SUBJECT: COMANCHE PEAK NUCLEAR POWER PLANT, UNITS 3 AND 4
DOCKET NUMBERS 52-034 AND 52-035
RESPONSE TO REQUEST FOR ADDITIONAL INFORMATION RELATED TO PART 1

Response to Request for Additional Information Related to Part 1,
Questions CP-01 through CP-06

**Comanche Peak Nuclear Power Plant, Units 3 & 4
COL Application
Part 1, Administrative and Financial Information**

**FIGURE 1.2-1
Simplified Ownership Diagram**

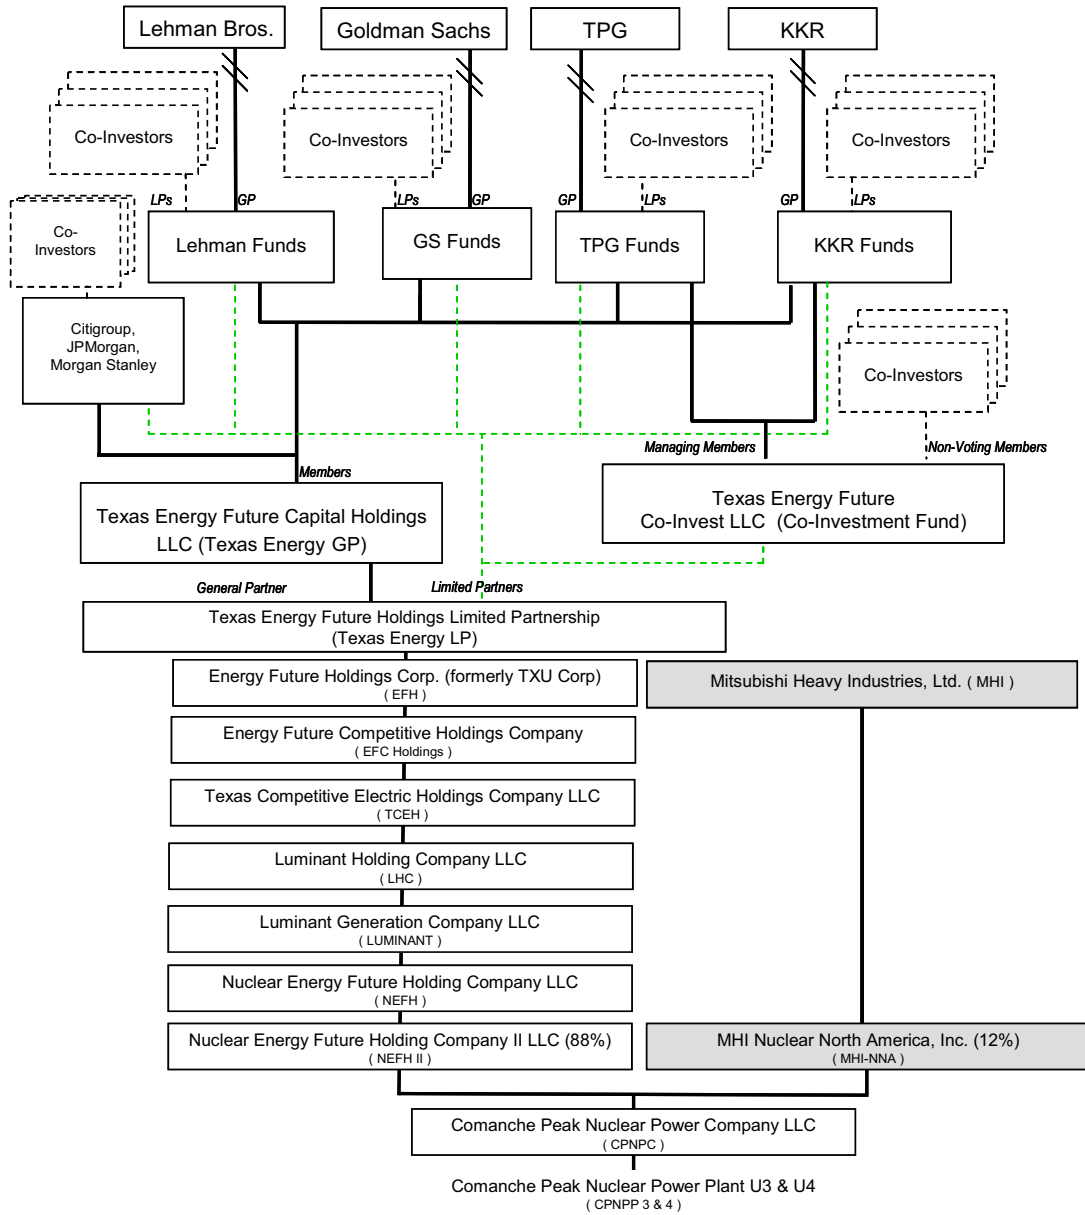
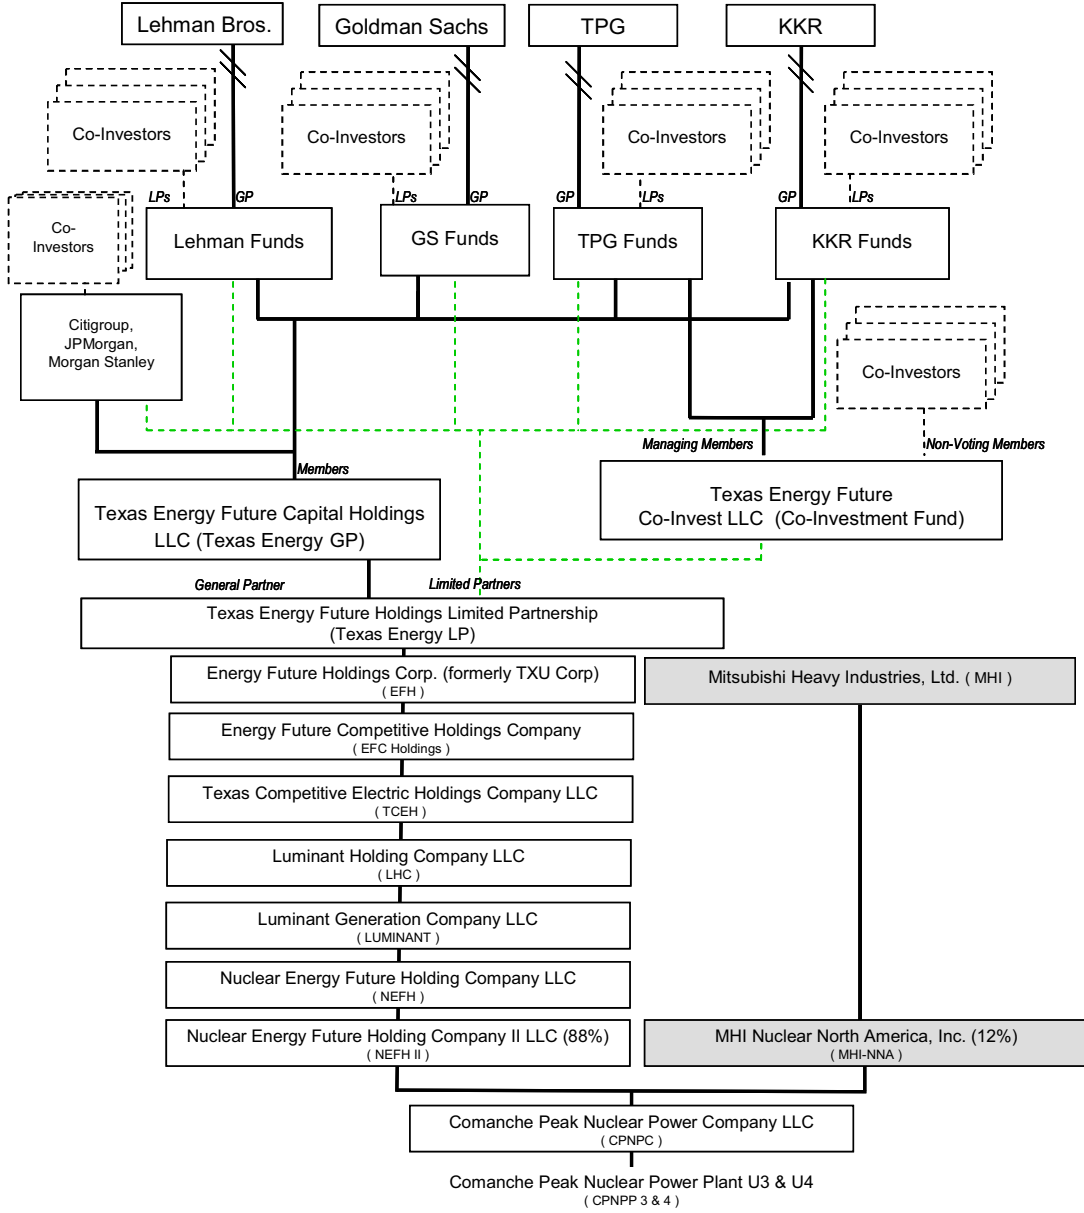
- a. Explain what relationship the joint venture, CPNPC, formed with MHI, will have with the overall corporate structure of Energy Future Holdings (EFH) and provide a diagram showing the relationships of MHI, the parent company, and subsidiaries within the EFH corporate structure.

Section 1.2.1 of COLA Part 1 has been revised to reflect that Luminant refers only to “Luminant Generation Company LLC”. Rev. 1 of Part 1 clearly reflects the relationship between parent companies and their subsidiaries as displayed in revised Figures 1.2-1 and 1.2-2.

reflected in Figures 1.2-1 and 1.2-2. These diagrams are attached for convenience. (see also Response CP-04).
